LANDMARK COMMISSION REGULAR MEETING **Public Notice**

June 3, 2024, Briefing at 10:00 A.M. and the Public Hearing at 1:00 P.M. Dallas City Hall, 6ES Council Briefing Room and Videoconference

AGENDA

Proposed new glass and sliding glass door.

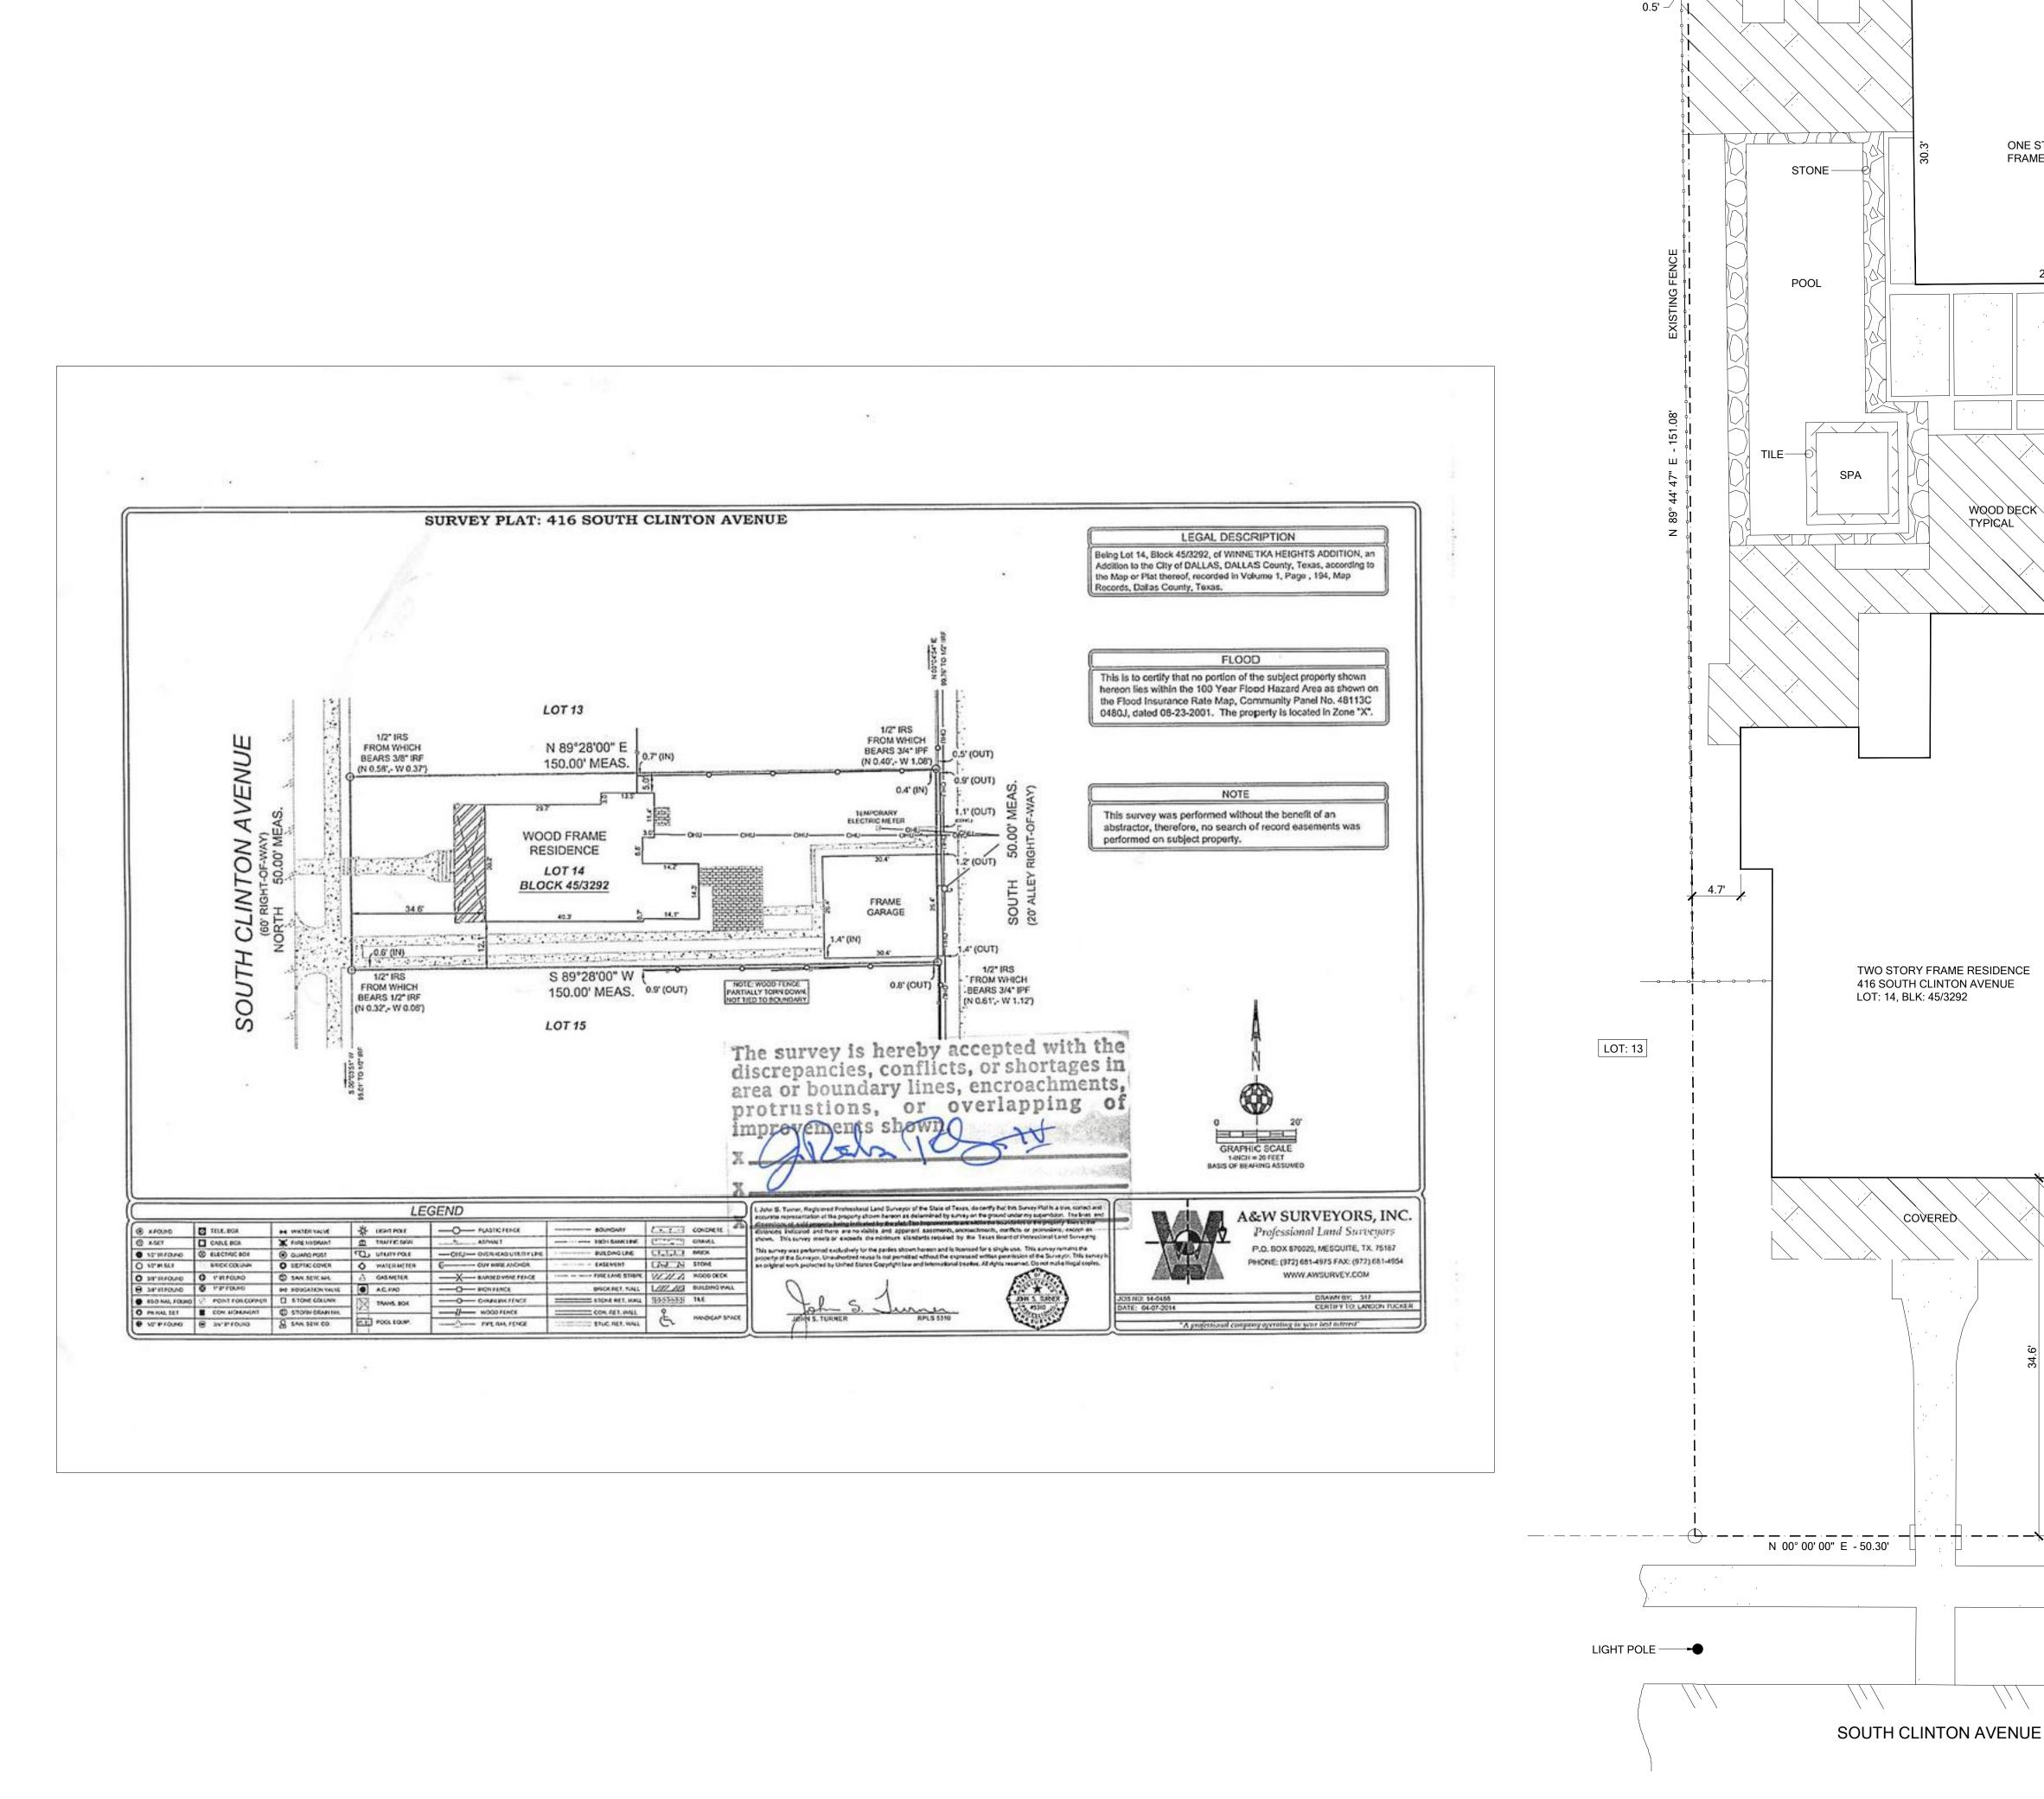
- That the request for a Certificate of Appropriateness to remove all existing windows on the north, east, west, and south sides of the rear "tower" addition be denied without prejudice. Need a window survey documenting window condition. Removing too much historic fabric; modernizing too much. Perhaps extend addition to make it work better.

Left Elevation where 3 replacement windows and hardie siding will be installed.

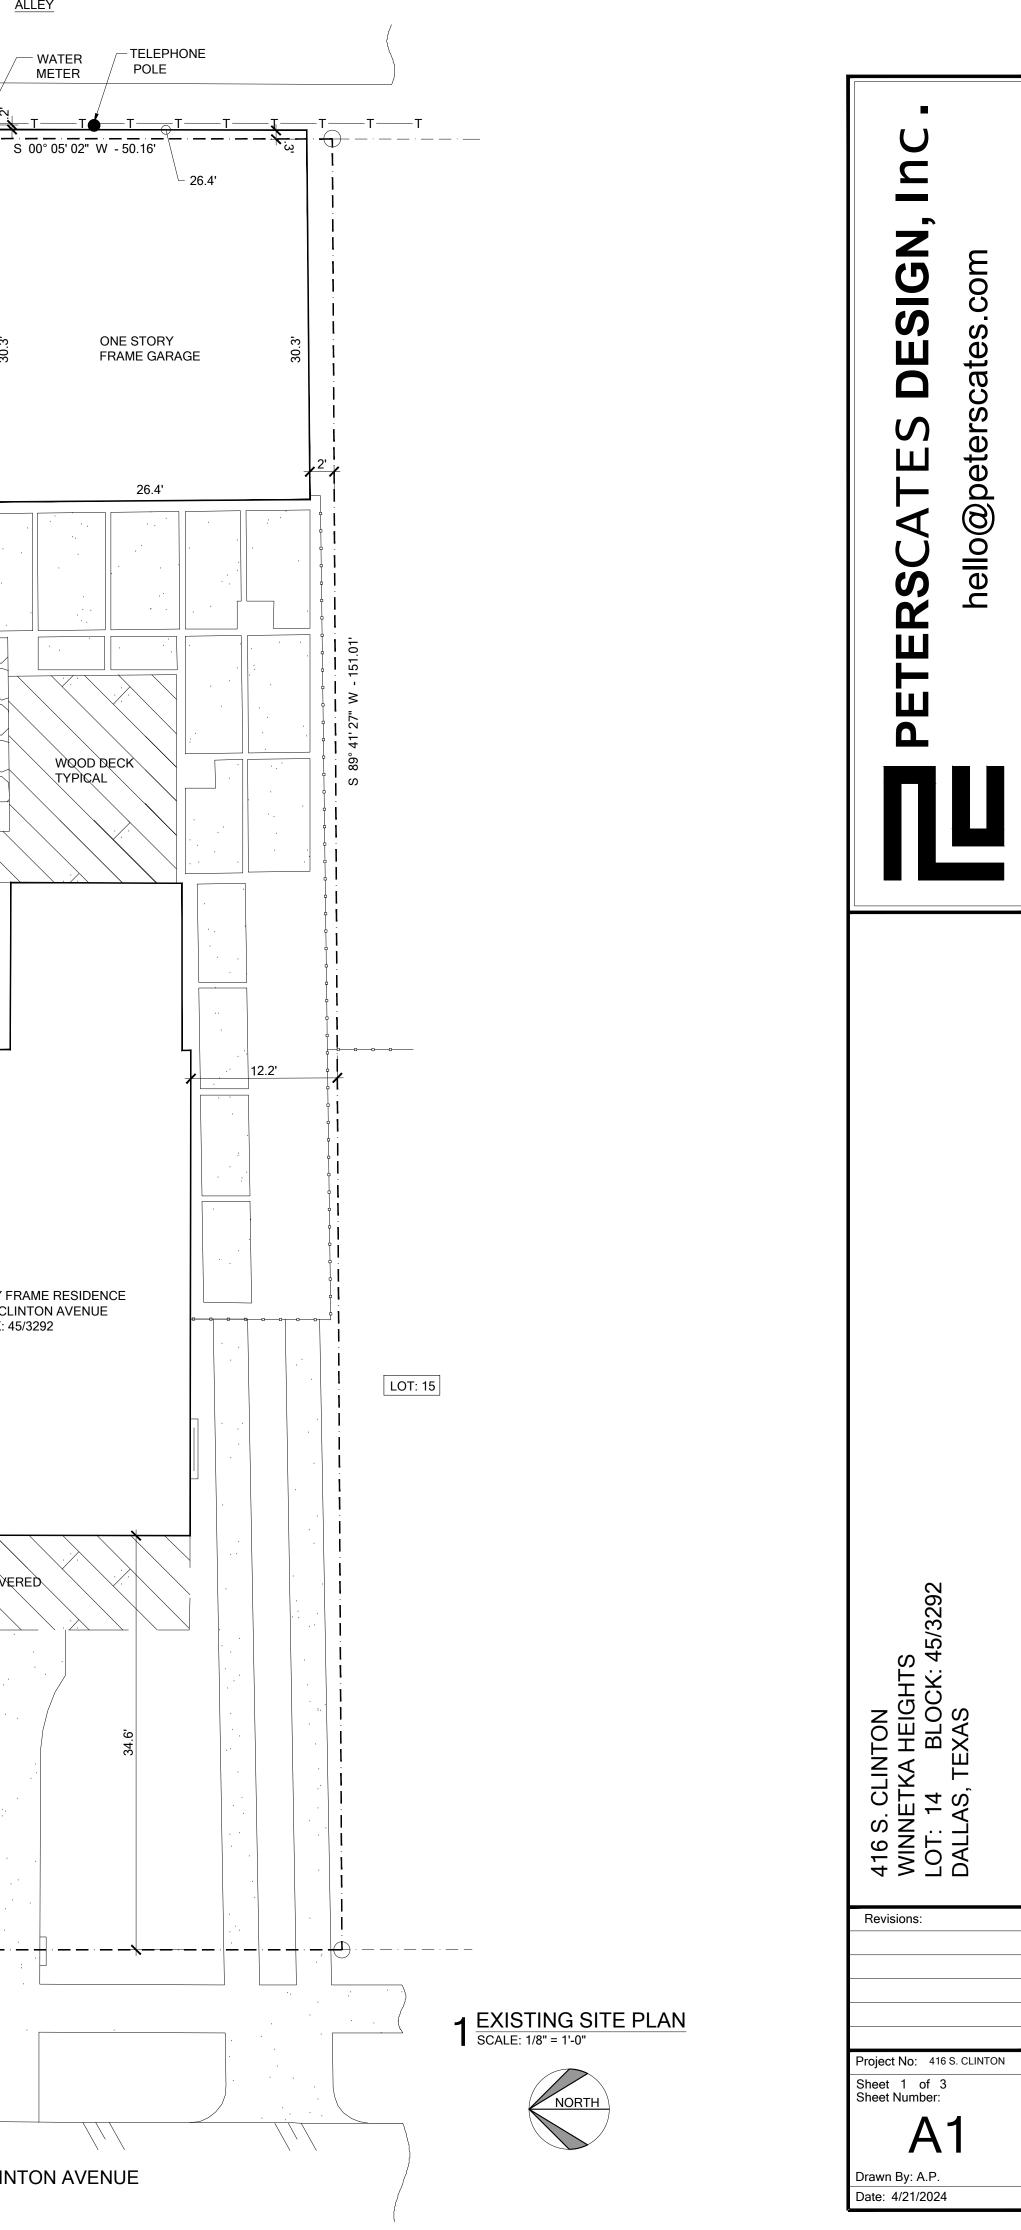
- 6. That the request for a Certificate of Appropriateness to replace three (3) windows on the north side of the main structure be denied without prejudice. Need a window survey documenting window condition. Removing too much historic fabric; modernizing too much.

- 6. That the request for a Certificate of Appropriateness to replace three (3) windows on the north side of the main structure be approved in accordance with drawings and materials dated 4/21/24 with the condition that the windows be all wood with no cladding. Implementation of this recommended condition would allow the proposed work to be consistent with preservation criteria Section 51P87.111(a)(17)(F)(iii); the standards in City Code

RETAINING WALL PLAN - PRE-EXISTING

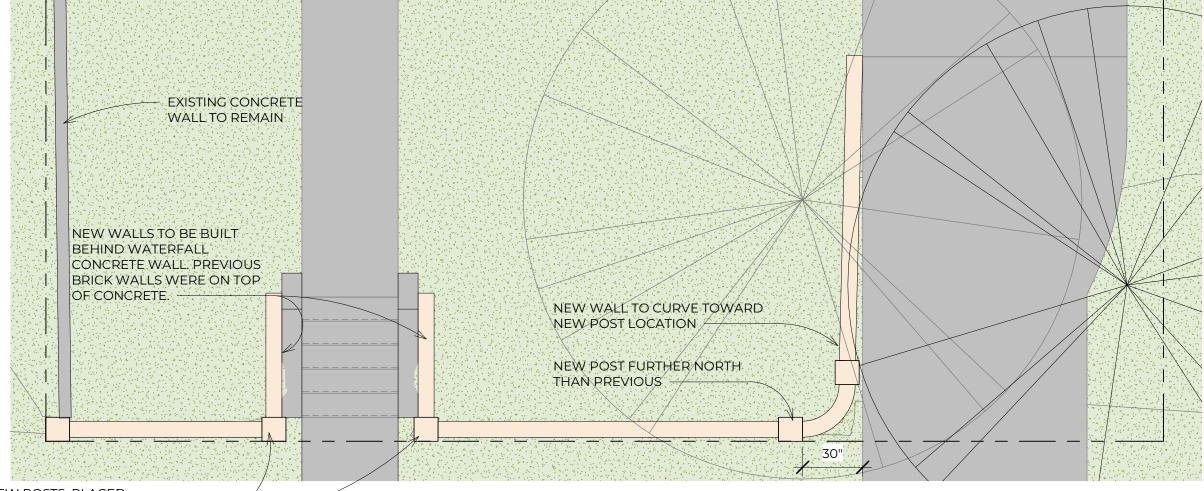
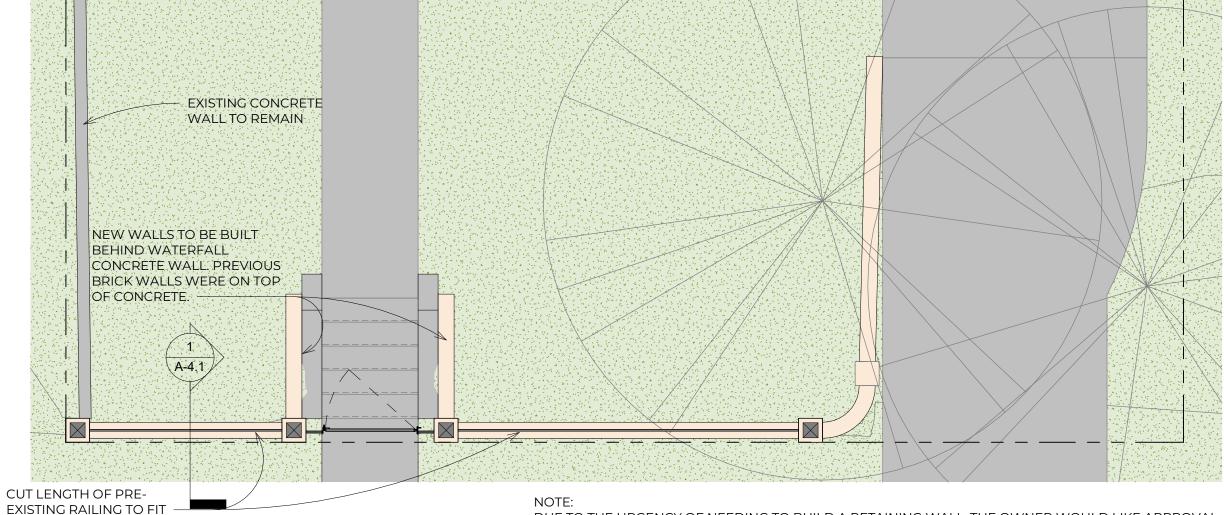
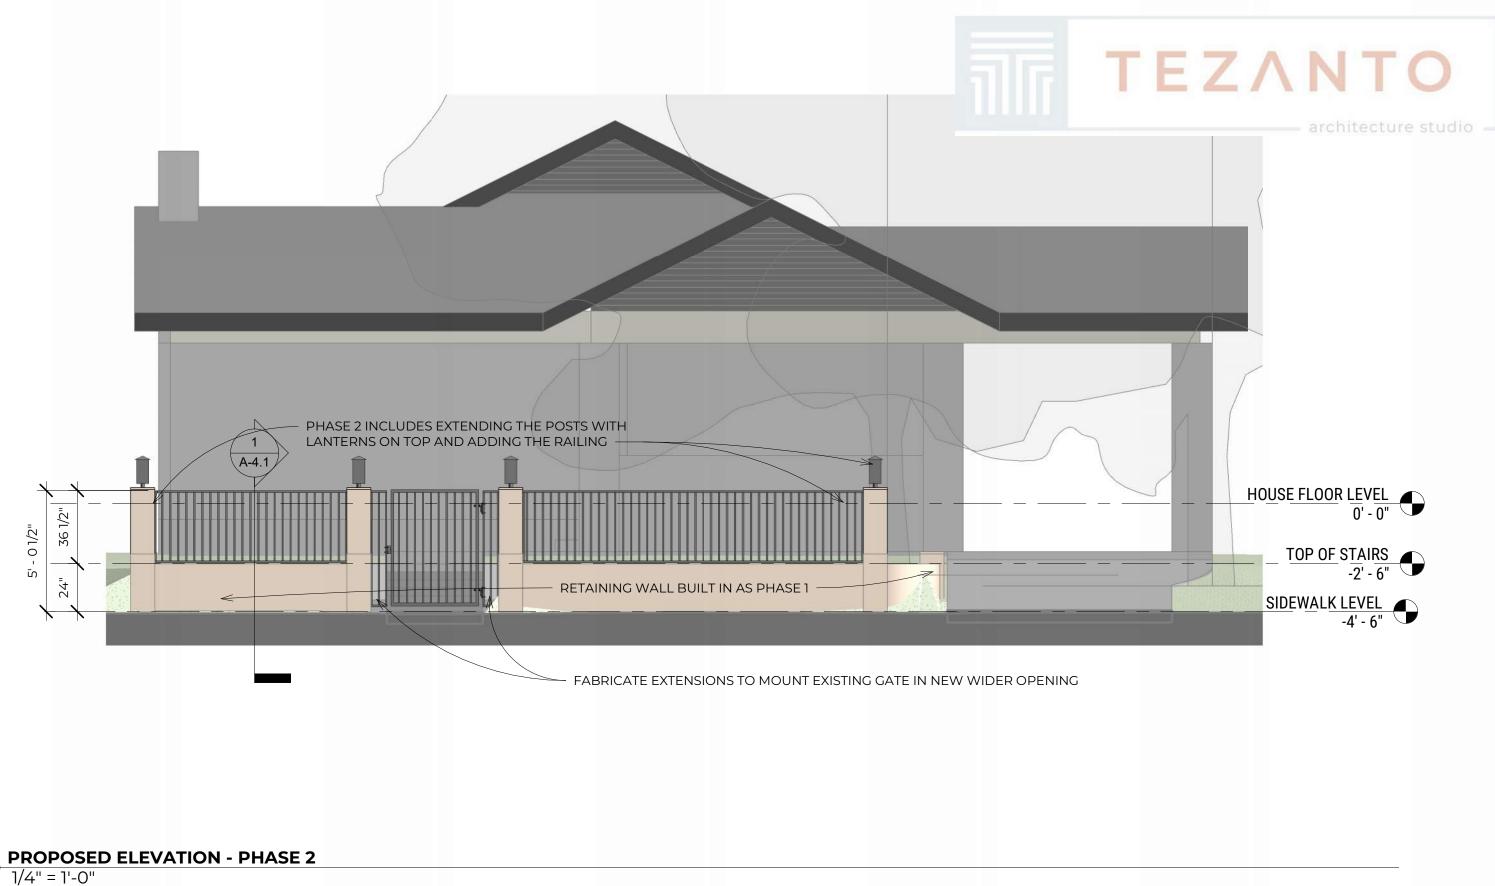
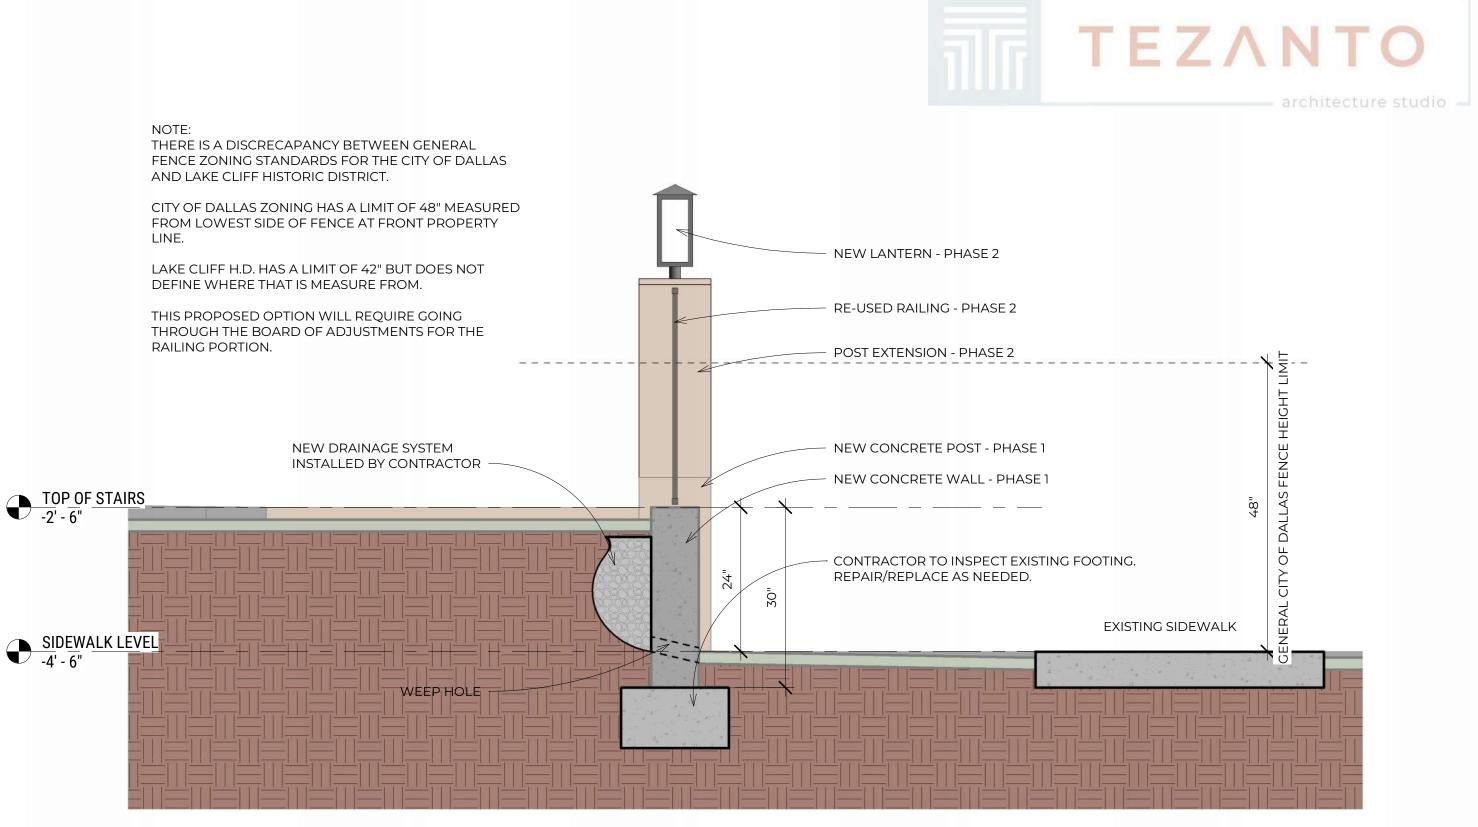
That the request for a Certificate of Appropriateness to replace the retaining wall and fence at the front yard on the west property line and partially along the driveway (unauthorized removal) be denied without prejudice. Property owner wants to rebuild old fence, but it would not meet zoning. Architect designed a wall to meet zoning, but concrete would not be good for the district.
